Item ID: D3041-7 Accept *N900040100* Setup Start *NS1*
 Revision ID: Stop *NS2*
 Item Name: Clamp
 Start Date: 1/20/15 Start Qty: 30.00 *30* Cust Item ID:
 Required Date: 2/06/15 Req'd Qty: 30.00 *30* Customer:
 Reference:

C	06.10.18	CHANGED BEARING HOLE TOLERANCE
B	06.06.05	CHG TO RND END DETAIL, 0.063 WAS 0.032, ADD TOL. & D3041-5/-7
A	01.06.28	NEW ISSUE
REV	DATE	DESCRIPTION
DESIGN	DRAWN BY	DART AEROSPACE USA, INC. PORT HADLOCK, WA
CHECKED	APPROVED	DRAWING NO. D3041
DATE	06.10.18	TITLE CLAMP
		REV. C SHEET 1 OF 2 SCALE 1:1
COPYRIGHT © 2001 BY DART AEROSPACE USA, INC. THIS DOCUMENT IS PRIVATE AND CONFIDENTIAL, AND IS SUPPLIED ON THE EXPRESS CONDITION THAT IT IS NOT TO BE USED FOR ANY PURPOSE OR COPIED OR COMMUNICATED TO ANY OTHER PERSON WITHOUT WRITTEN PERMISSION FROM DART AEROSPACE USA, INC.

DRAWING NO. D3041	TITLE CLAMP	REV. C	DART AEROSPACE LTD ENGINEERING ORDER		D.E.O. NO. D3041-C-1	SHEET NO. SHEET 1 OF 1	SCALE NTS
DRAWN ADS	CHECKED	MFG. APPR.	APPROVED		DE APPR.		
DATE 09.03.04	DATE 09.03.12	DATE 09.03.12	DATE 09.03.13		DATE 09.03.13

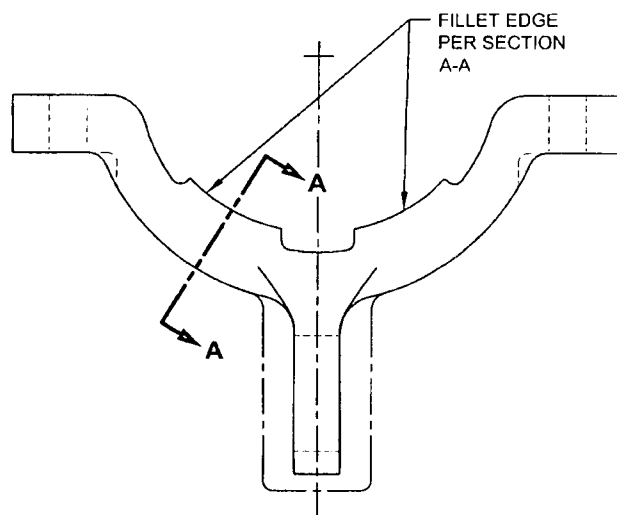
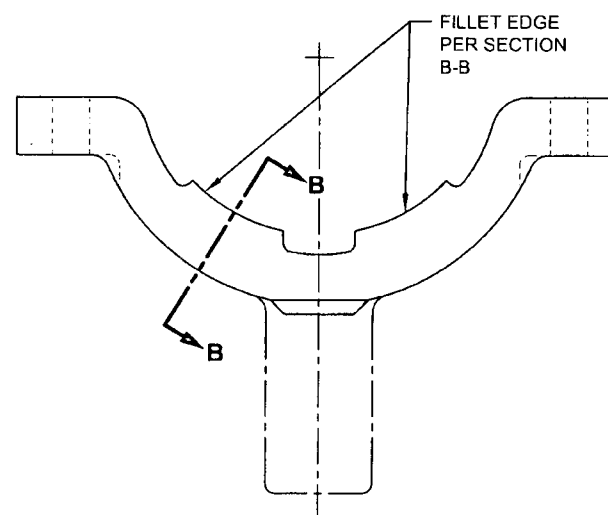
ADD FILLETS TO -1/-3/-5/-7 PER SECTIONS A-A AND B-B TO PREVENT CHAFING OF RUBBER CUSHIONS AS SHOWN:

R0.060 MIN - R0.10 MAX
2PL

SEE PAR 122 FOR FURTHER DETAILS
